COPPERSTRING EIS

Attachment F - Vegetation Clearing Works plans

Flinders Substation to Dajarra Road Substation

FLR_DJR_298

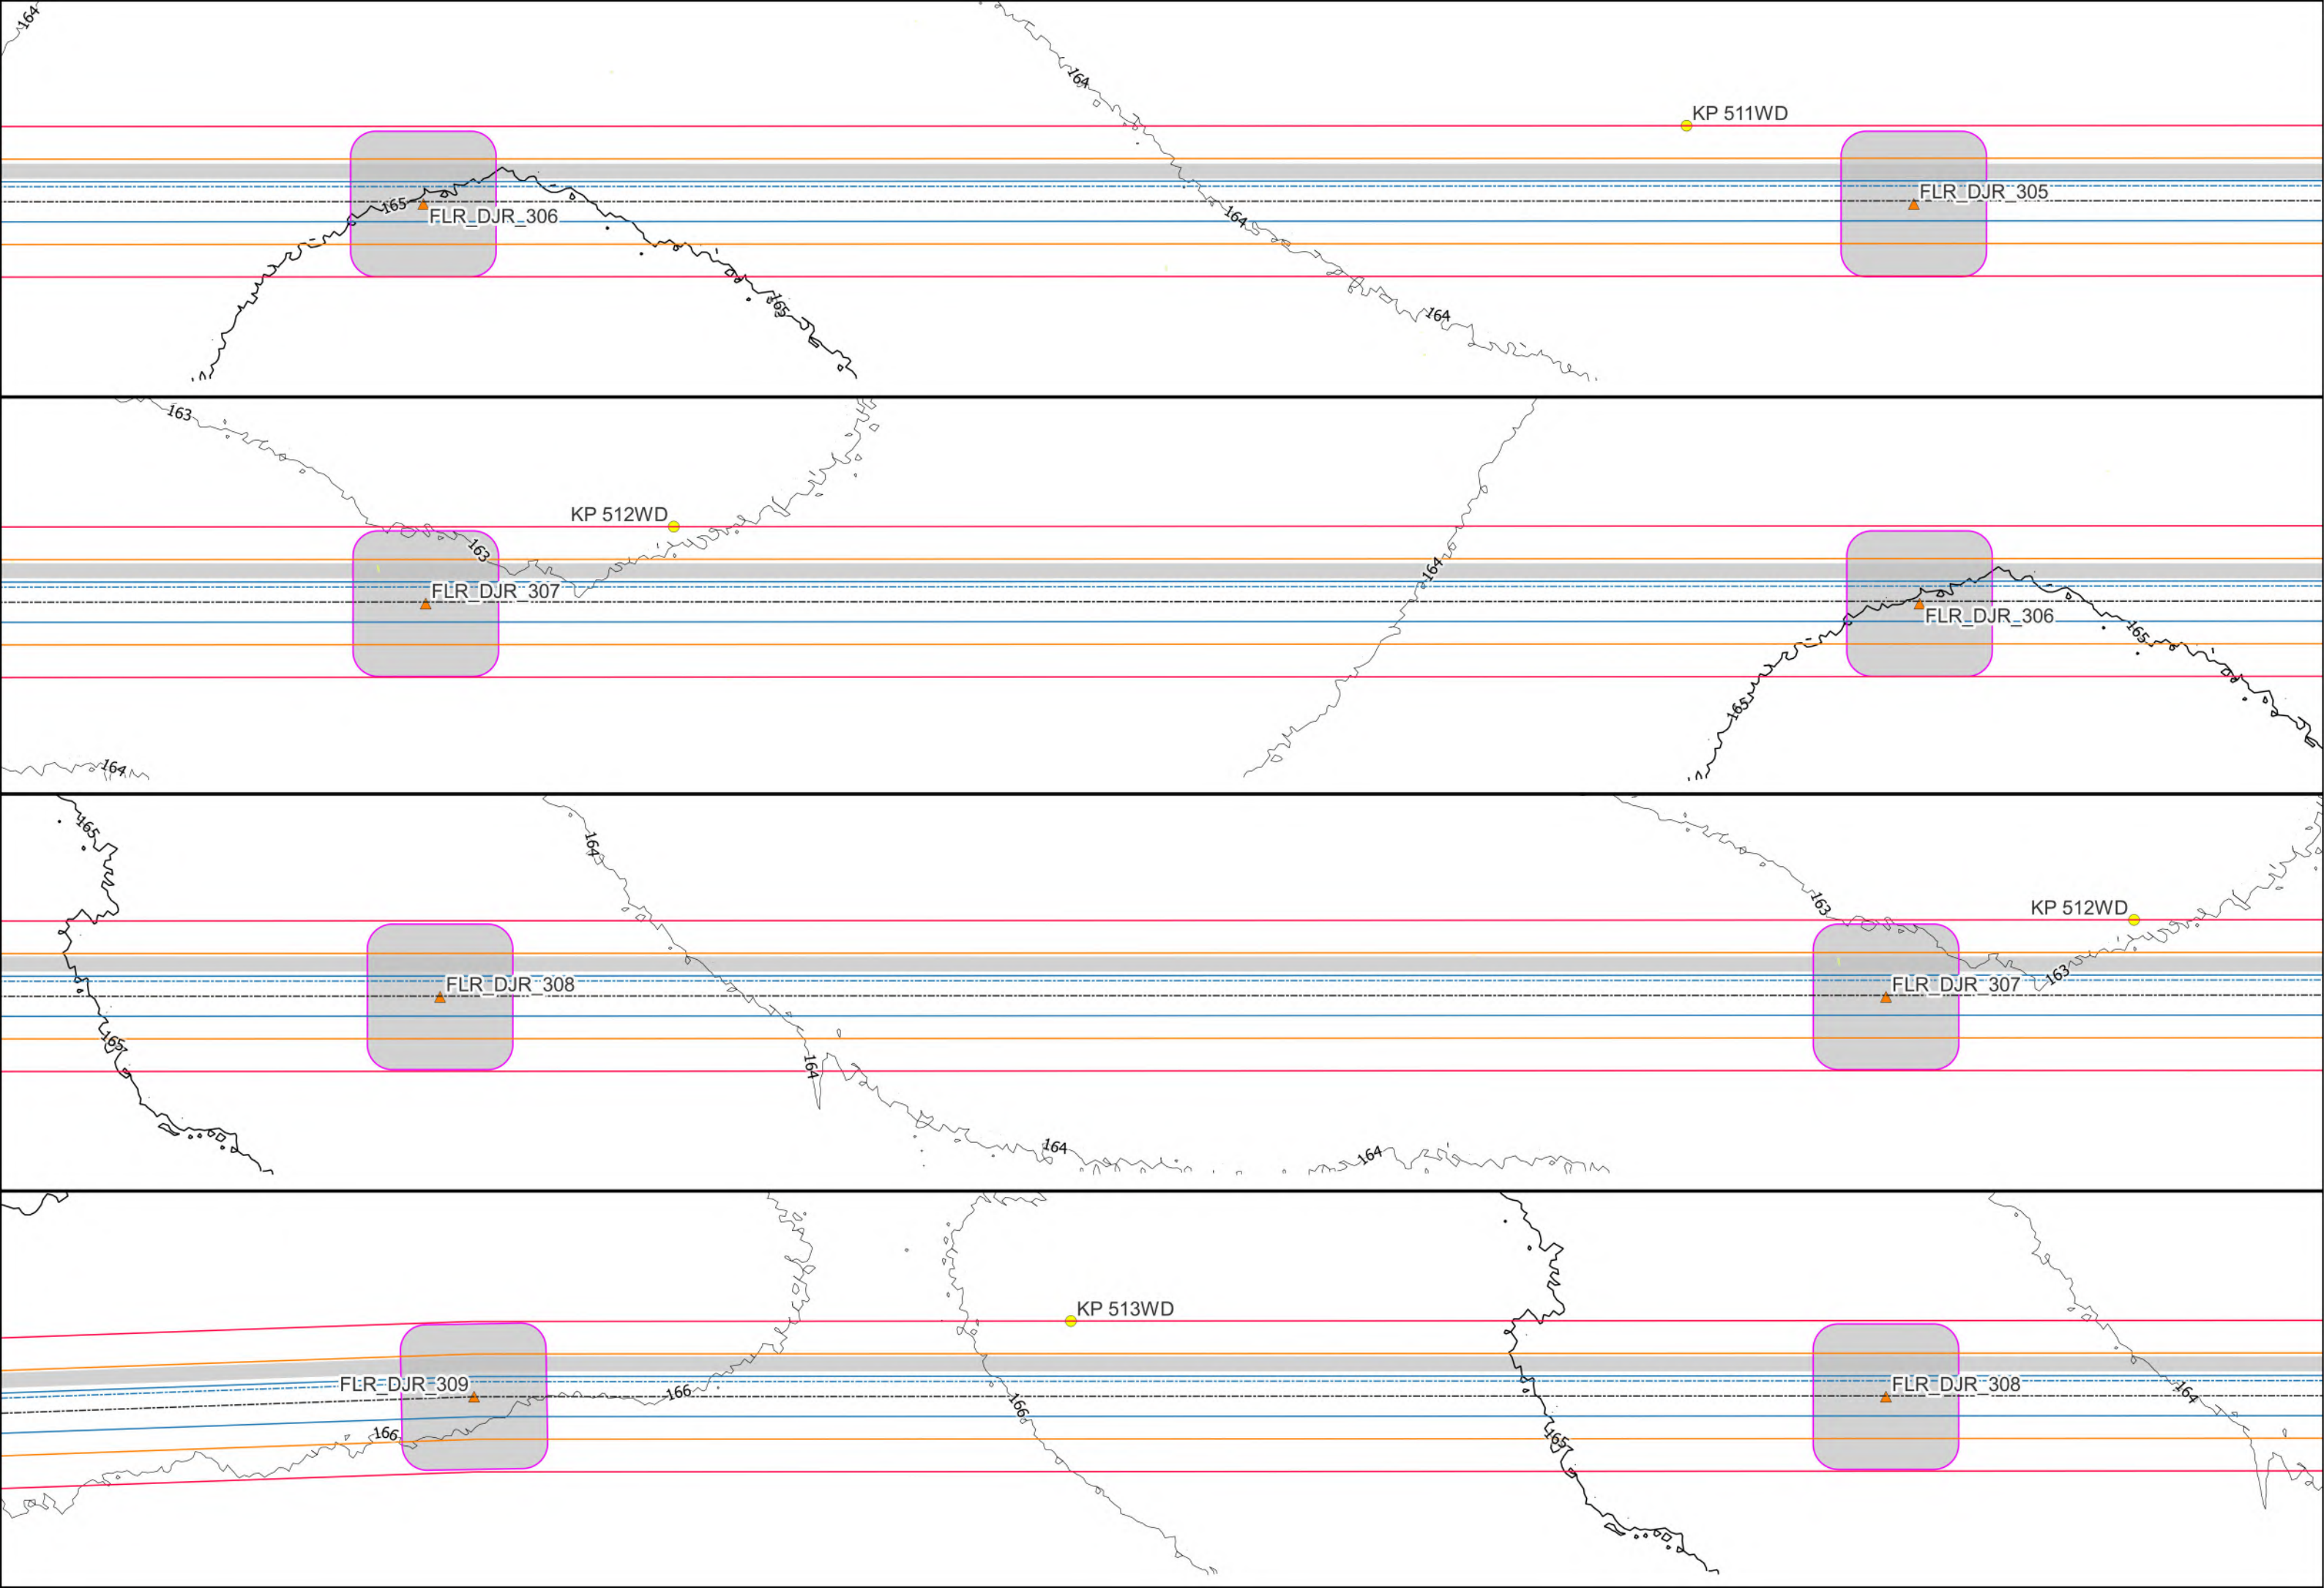
Clearing for conductor clearance within 15m of the high bank of waterway to occur 1.5m above ground level by hand to minimise disturbance to ground and roots which contribute to bank stability.

FLR DJR 362

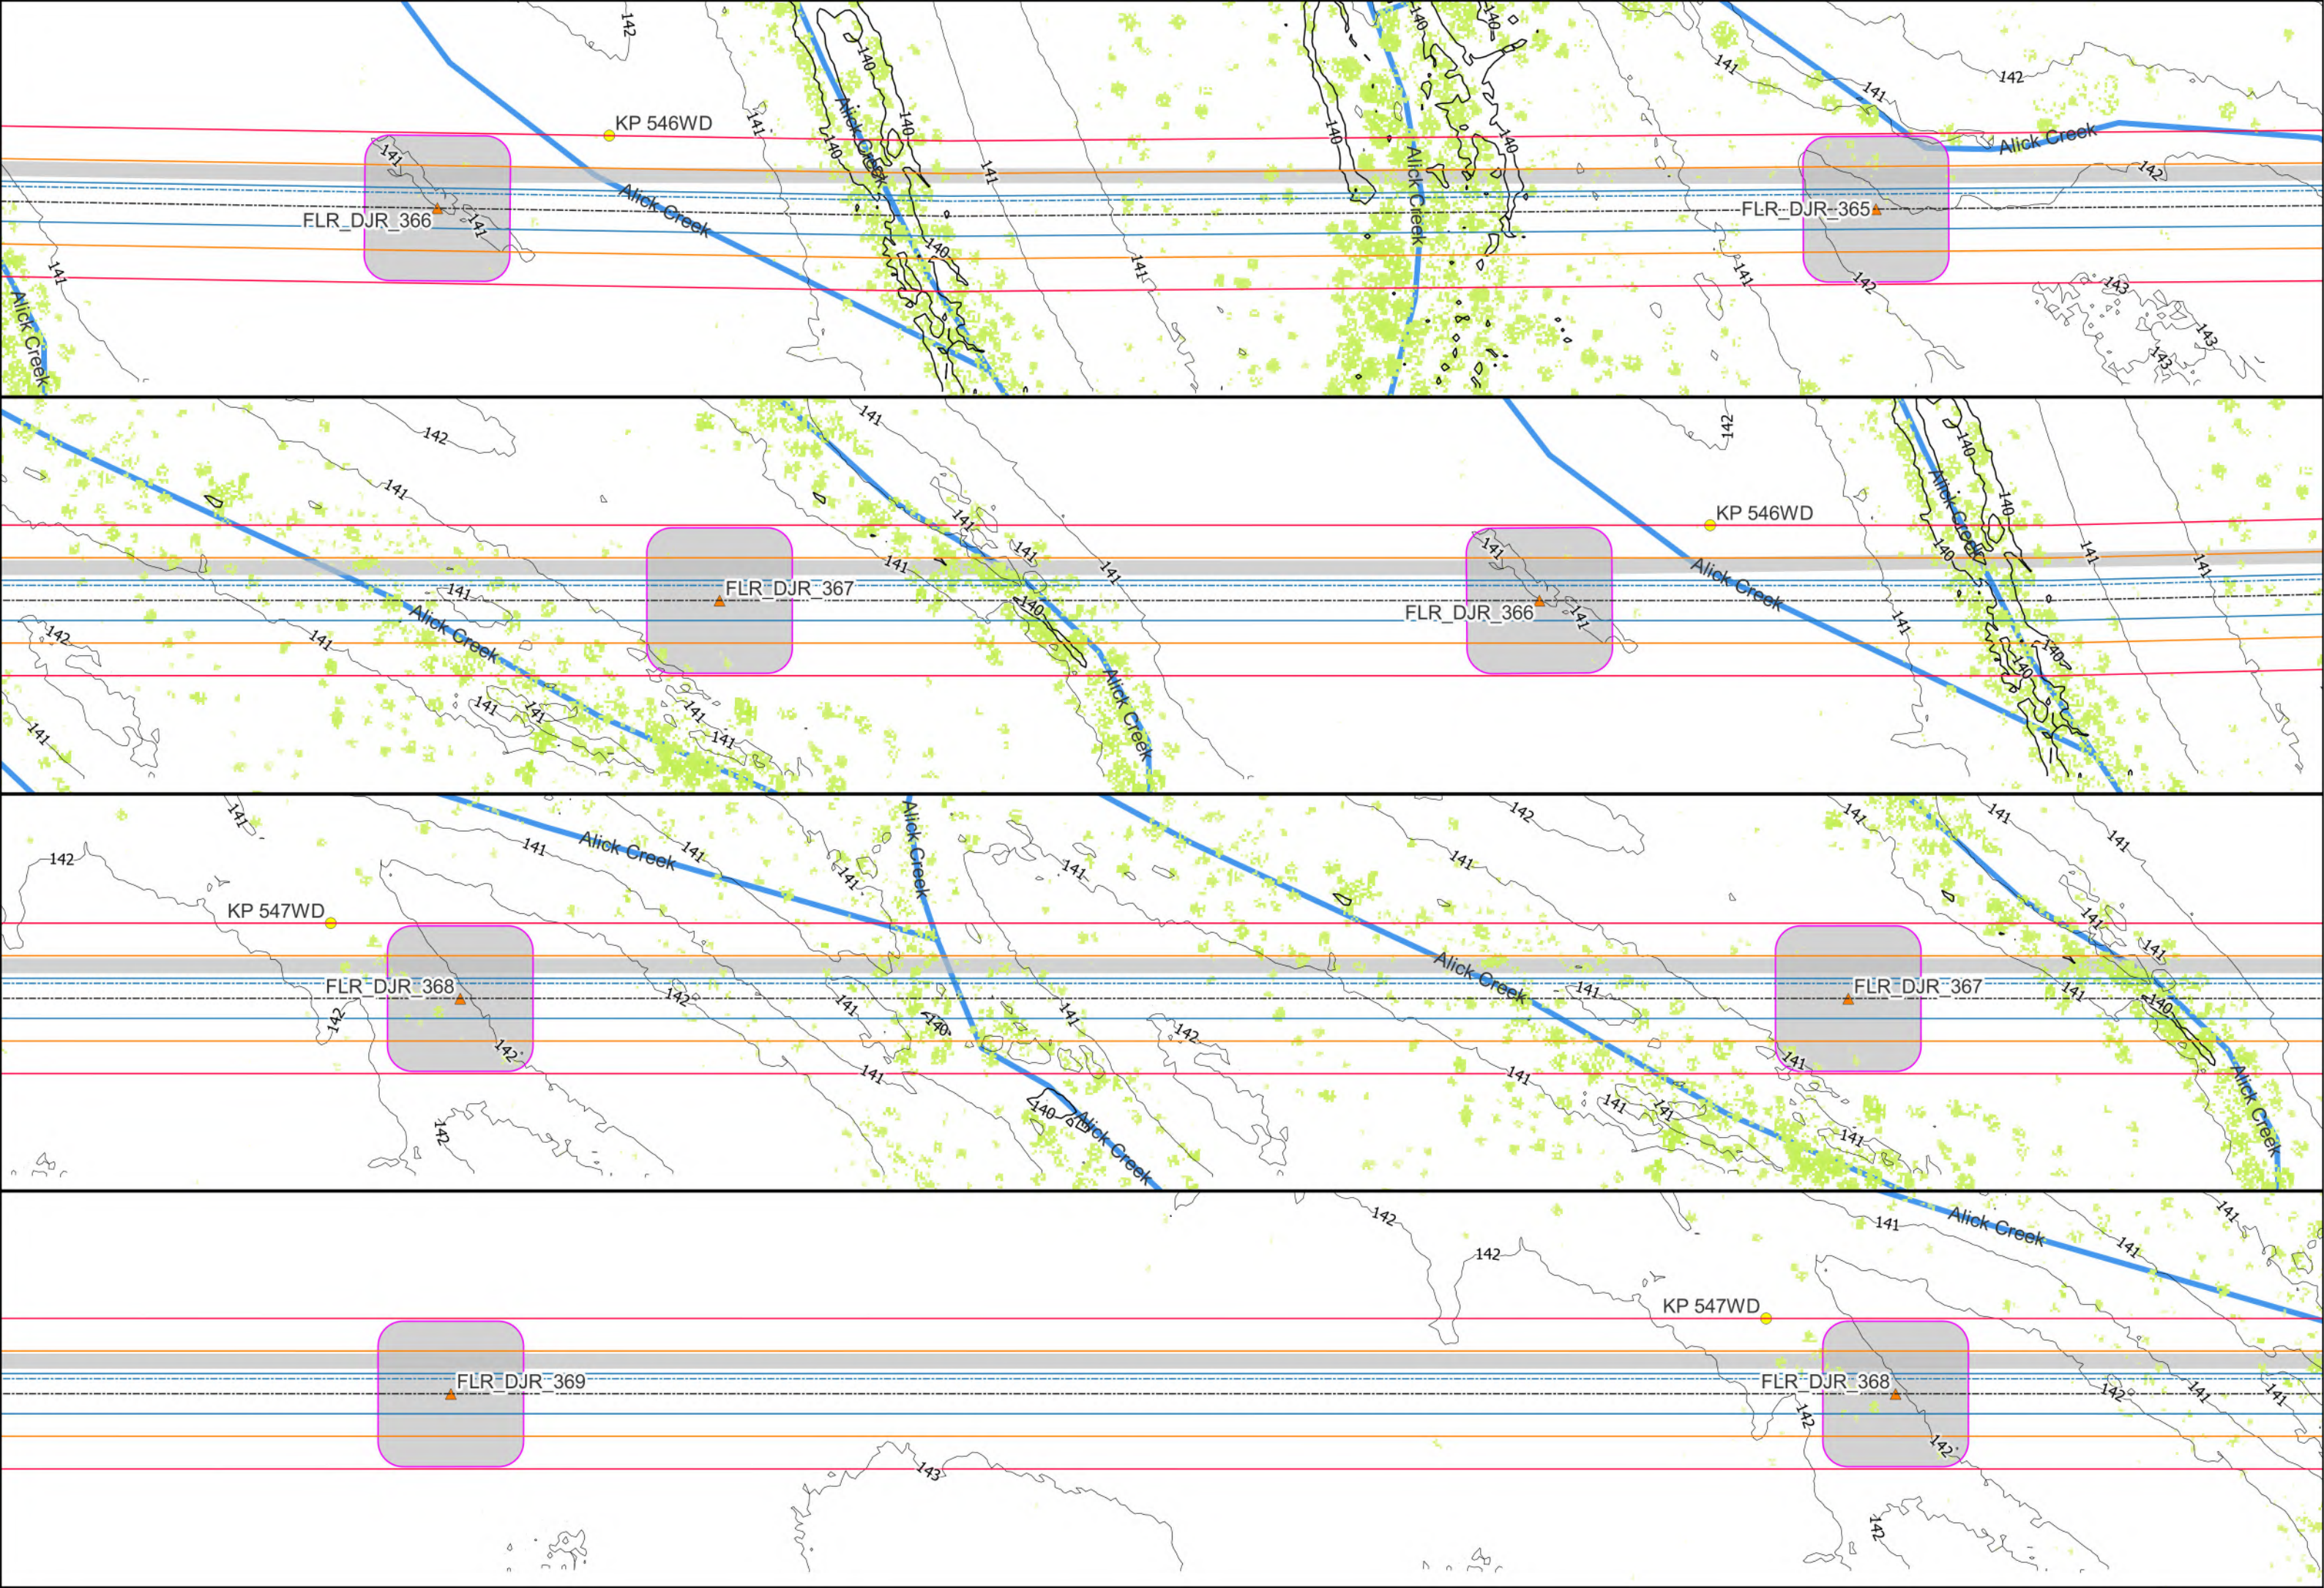
Tower assembly area to be reconfigured to not be within 15m of the high bank of waterway and to avoid clearing near or within the bed and banks for the waterway.

FLR DJR 363

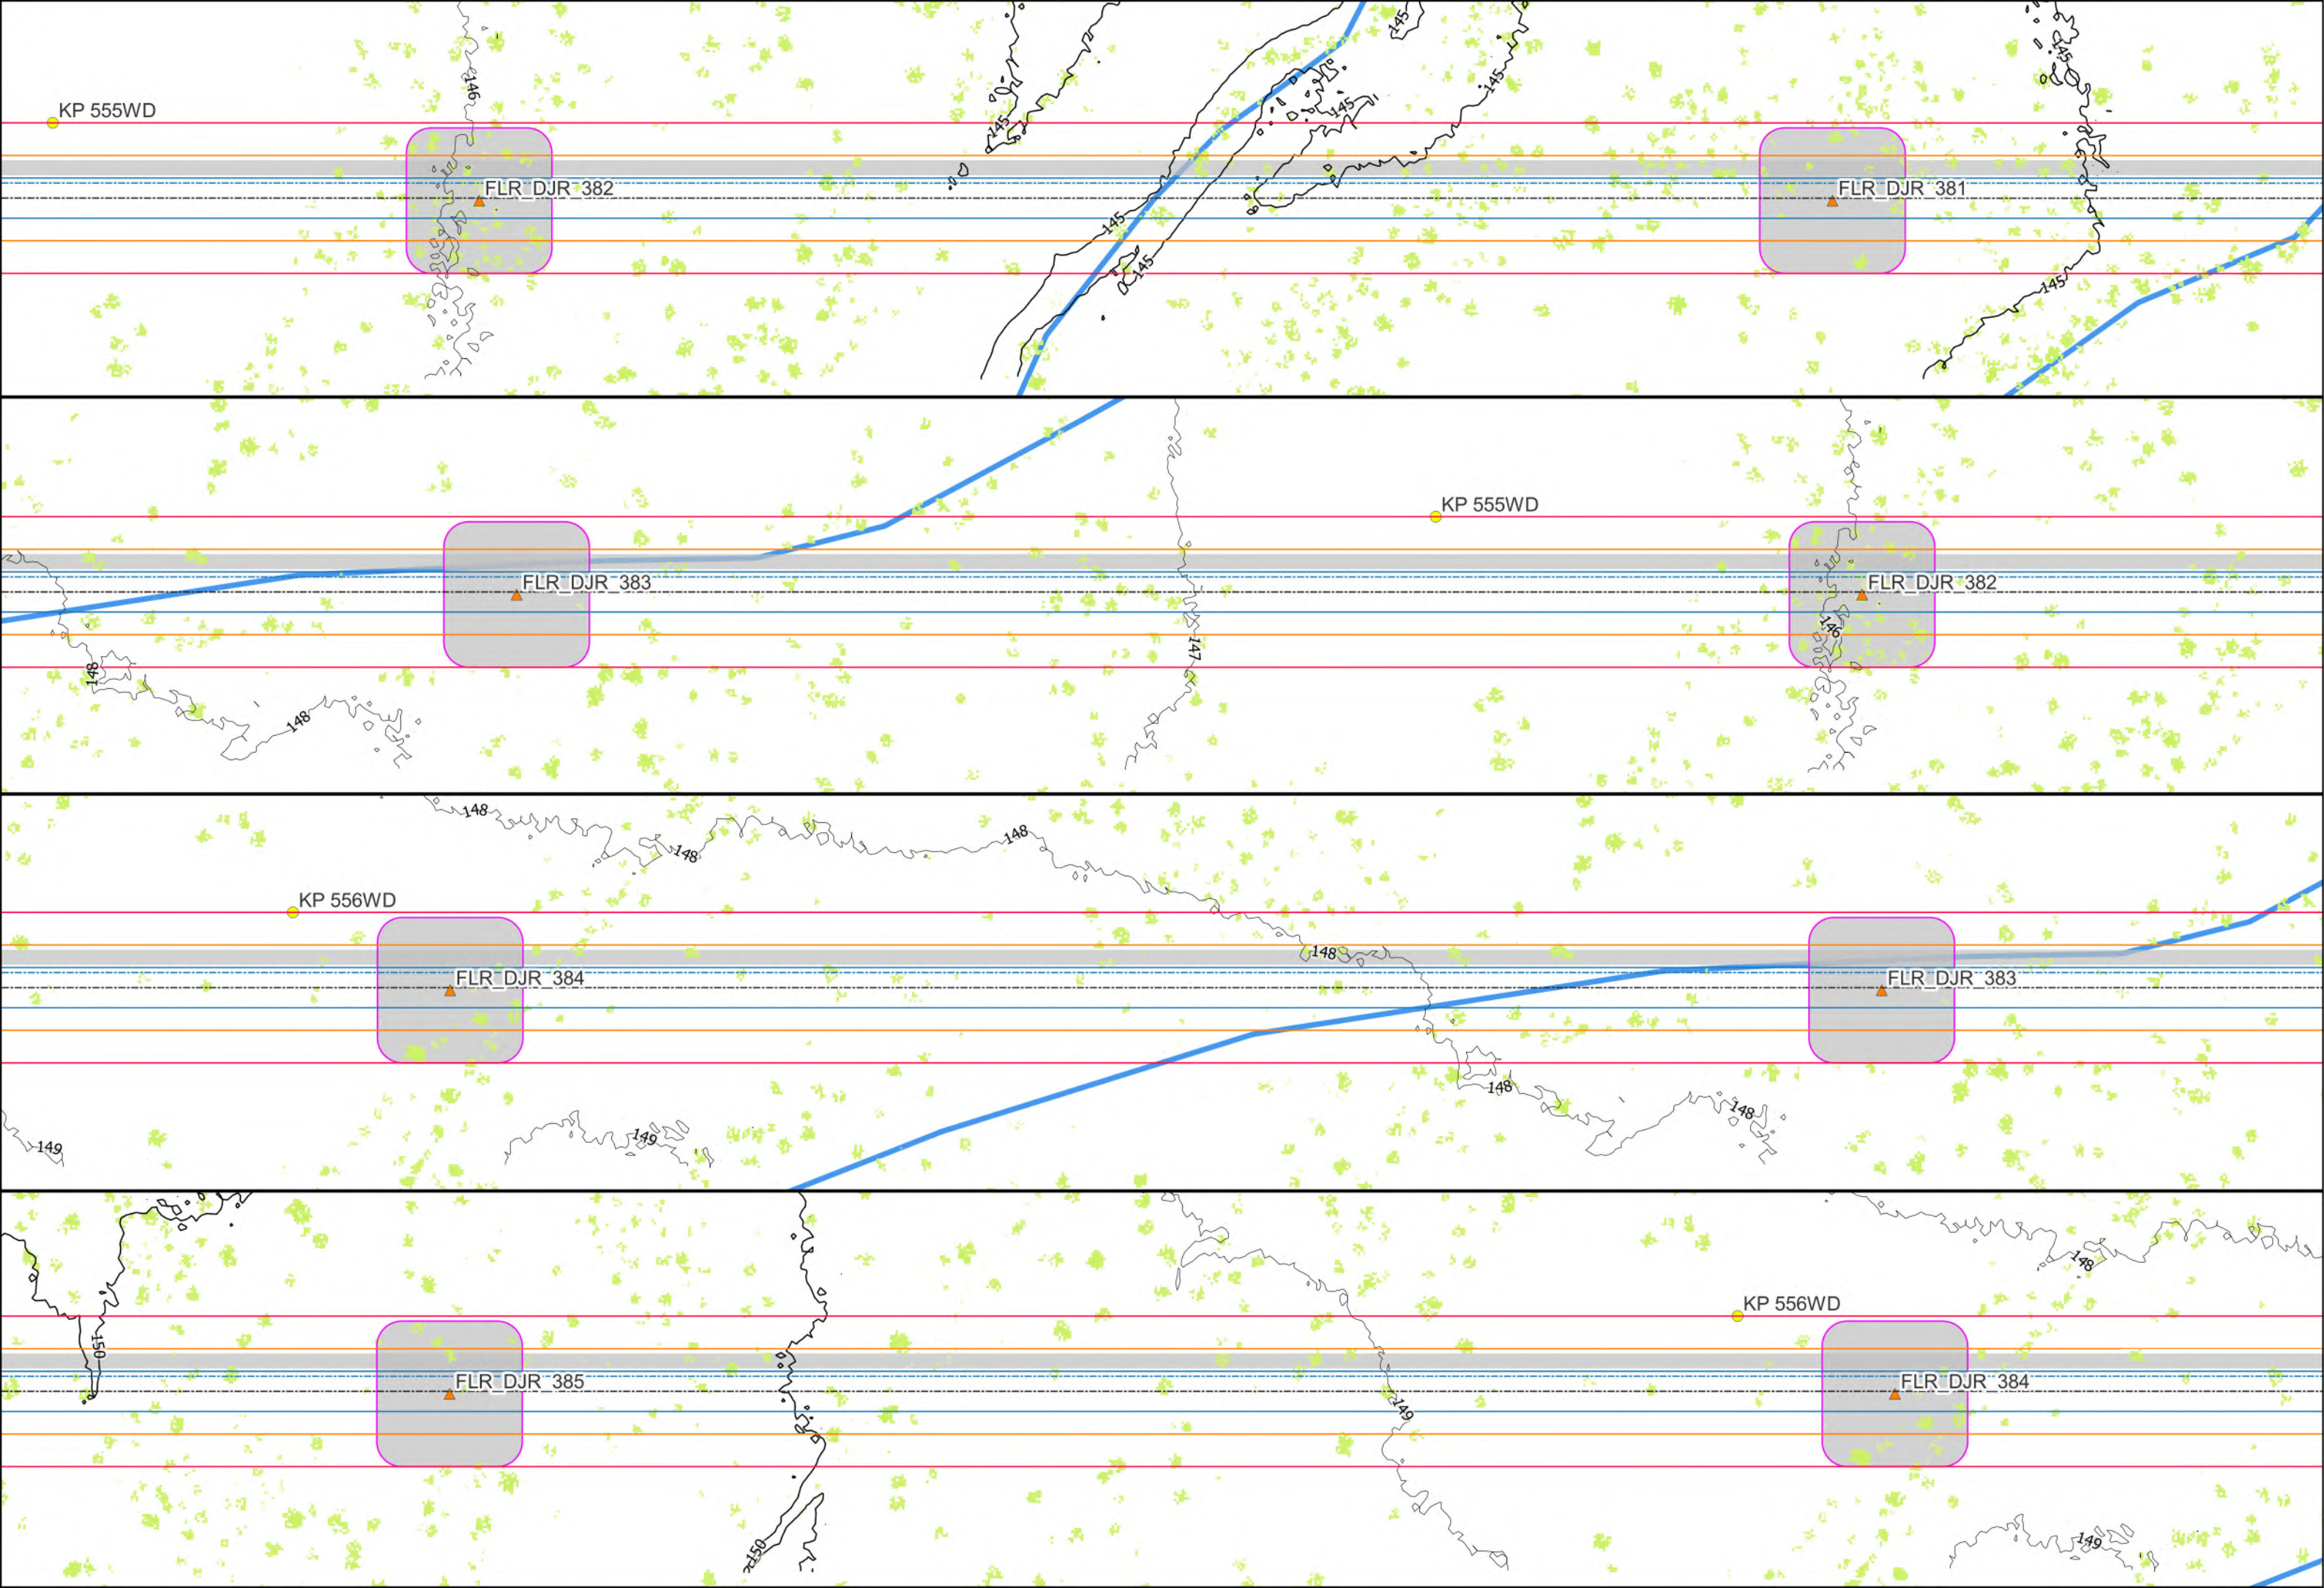
Tower assembly area to be reconfigured to not be within 15m of the high bank of waterway and to avoid clearing near or within the bed and banks for the waterway.
